M-2004-051 Technical Revision 04 - Wattenberg Lakes Mine

RE: Wattenberg Lakes Aggregate Mining Design Modifications, Weld County, Colorado; U.S Army Corps of Engineers (Corps) File No. NWO-2000-80189-DEN

Wattenberg Lakes Gravel Mining Revised Compensatory Mitigation Plan Weld County, Colorado

Figure 4
Mitigation Plan

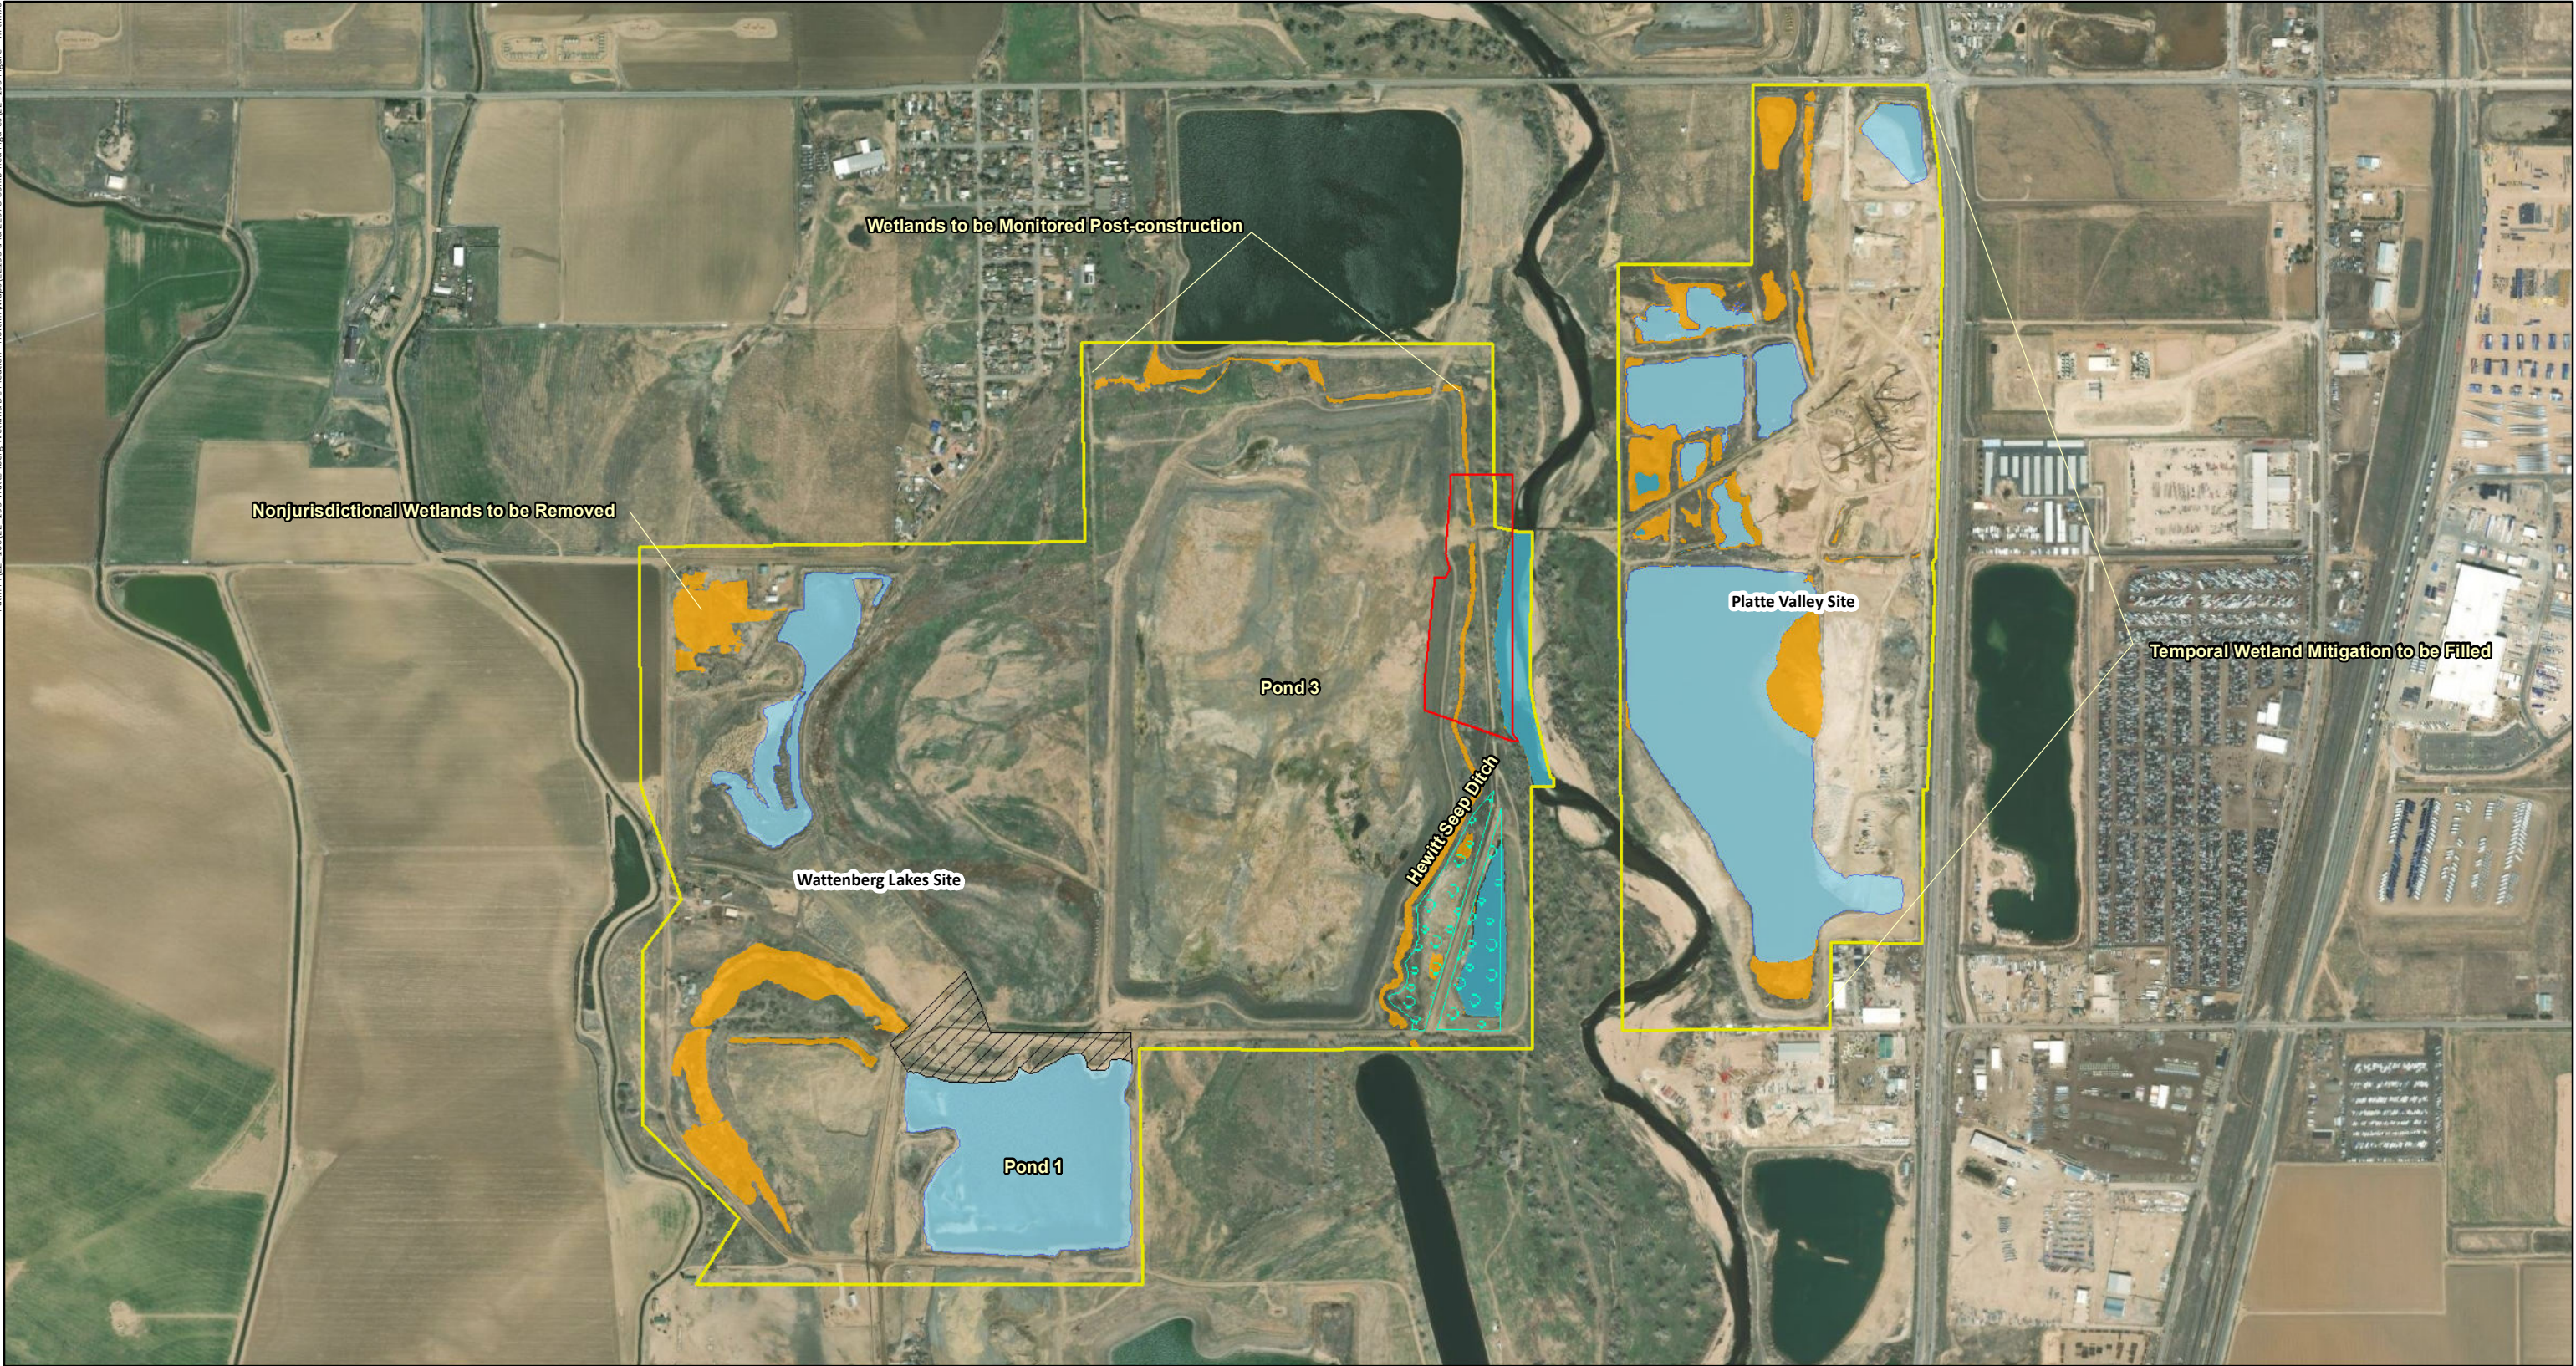
Based on this revised mitigation plan, Holcim requests the following amendments from the original IP conditions. The proposed mitigation and modification areas are shown on Figure 4.

- The original IP included 7.05 acres of temporal wetland mitigation to be constructed on the Platte Valley site, east of the South Platte River, to provide relief from temporal losses during the mining process. Based on this revised mitigation plan, the 7.05 acres of wetlands that were created for temporal loss would no longer be required and Holcim can fill in those areas.

- Holcim requests the cottonwood replacement requirement and mitigation areas (southwest of Pond 3) be removed as the mitigation would now be fulfilled with Bank credits and no longer necessitate supplementary PRM.

- The area north of Pond 1 would be graded lower to minimize impacts from the Pond 1 slurry wall and to help maintain hydrological connectivity with the oxbow and wetland slough to the north and west.

- The nonjurisdictional wetlands in the northwest corner of the Wattenberg Lakes site would be filled per the original IP.
